Georgetown Charter Township

Planning Commission Meeting Agenda

6.I. Site Plan (Revision) – (ST1615) Advanced Interiors – 6656 Pine Ridge Ct.

Site & Special Use Plan - 6656 Pine Ridge Ct.

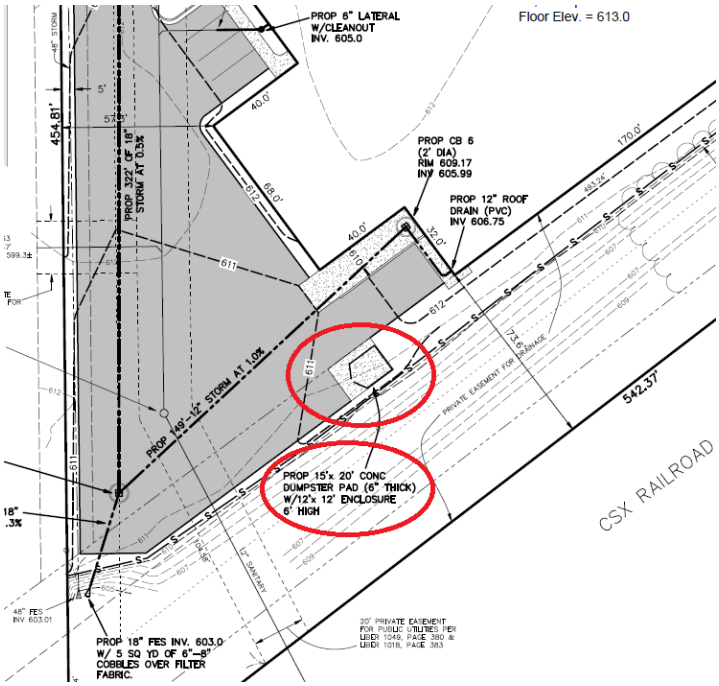
At the November 5, 2014 meeting, the Planning Commission approved a special use permit and site plan showing the dumpster to be located on a cement pad and enclosed with a six foot high fence.

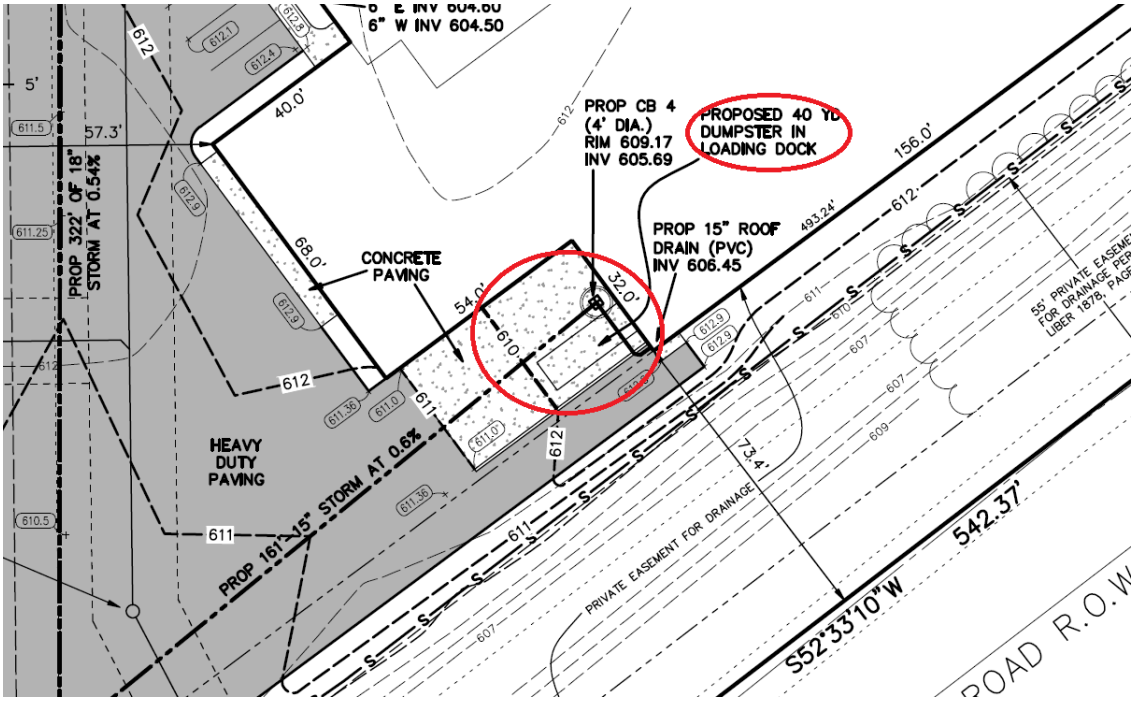
The request is to locate the dumpster in the truck well and to have no screening.

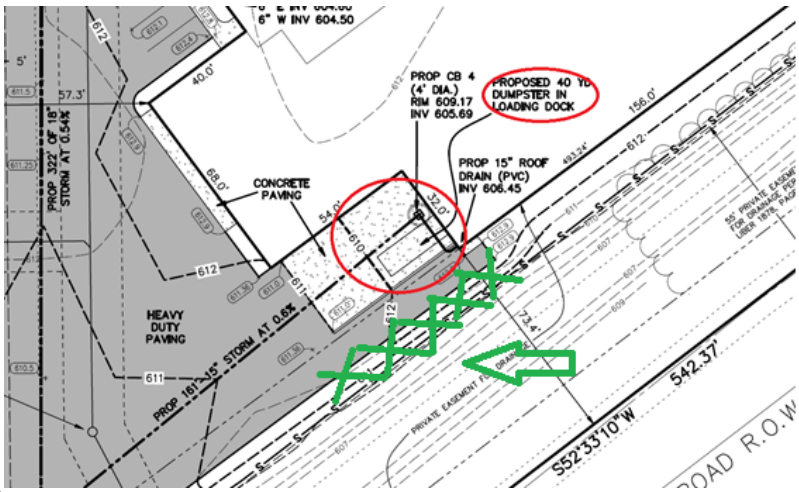
Although the Zoning Ordinance gives the Zoning Administrator the authority to approve site plans and to approve minor changes, the determination was made that this change should return to the Planning Commission since the Planning Commission initially approved the site plan that was part of the Special Use Application. Further, the approved the site plan with the dumpster on a cement pad and with screening, was based on the language in the ordinance. Therefore, the Planning Commission should determine if the new location is appropriate and if it should be allowed with no screening.

The Zoning Administrator offered to approve the new location with screening (either six foot high fencing or landscaping) to be added along the outside of the lane as shown in the drawing above. However, the applicant stated that the area is not visible from Chicago Dr. due to a berm that is covered with weeds that screens the site and is, therefore, requesting no screening.

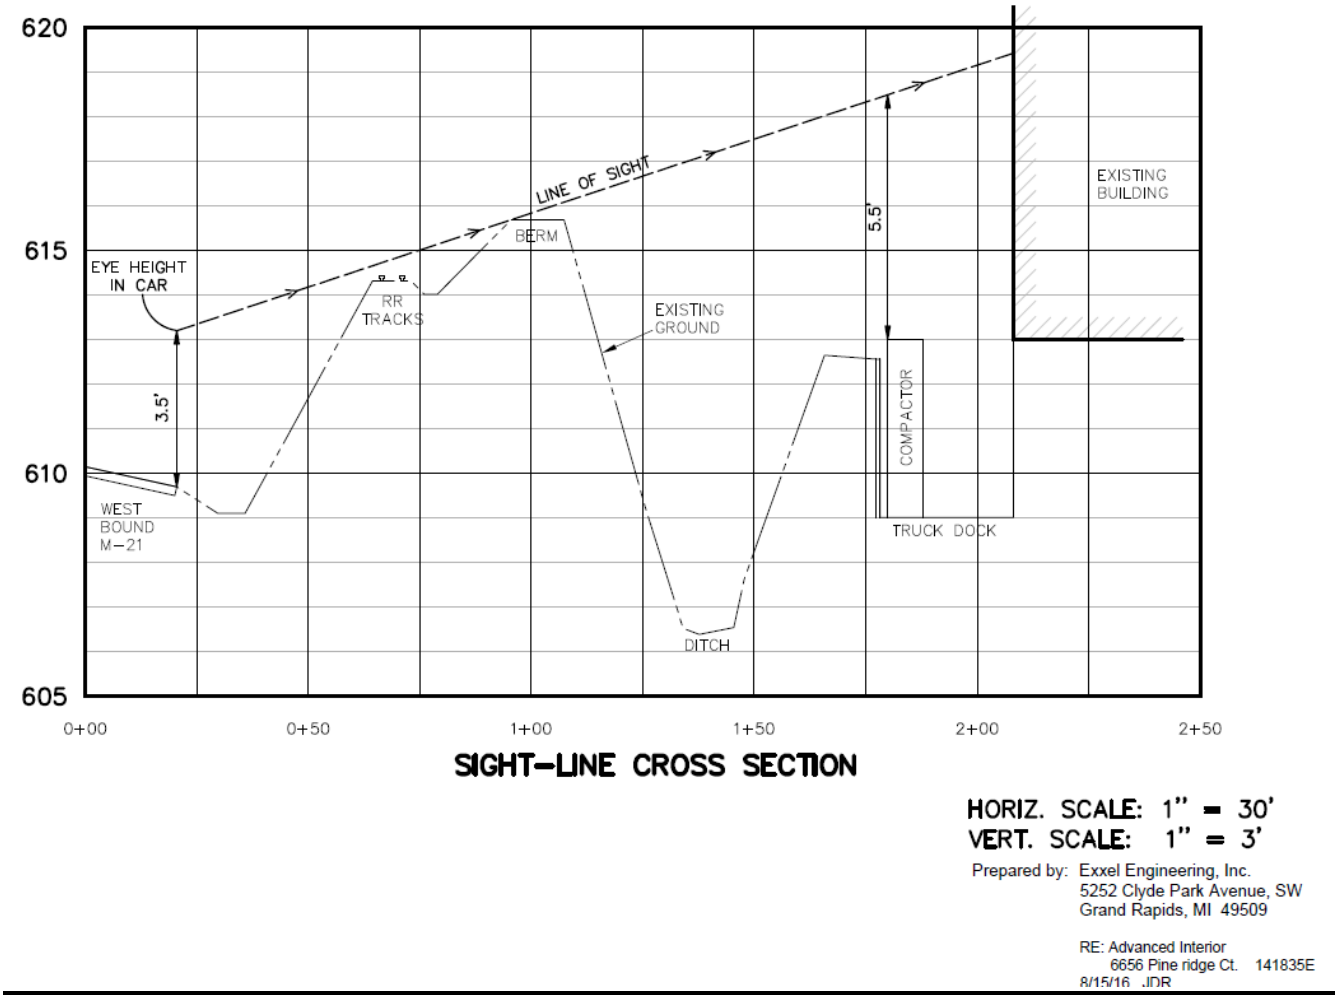
Below is the line of sight submitted by the applicant.

The concern of Code Enforcement is that they are requesting no screening and using the natural berm along with the weeds that grow on it as the screening. This area does have excessive weed growth along with other plants and flowers along a water way. The excessive weed growth and grass over 10" is a violation of our ordinance 62-27. The use of the grass and weeds as screening could be affected if enforcement of our code was necessary due to a complaint, change in enforcement philosophy or they become a negative effect on the waterway.

1. Is the location of the dumpster acceptable in the truck well?
2. If yes, should the area be screened (on the Chicago Dr. side of the interior lane) with either six foot high fencing or landscaping?
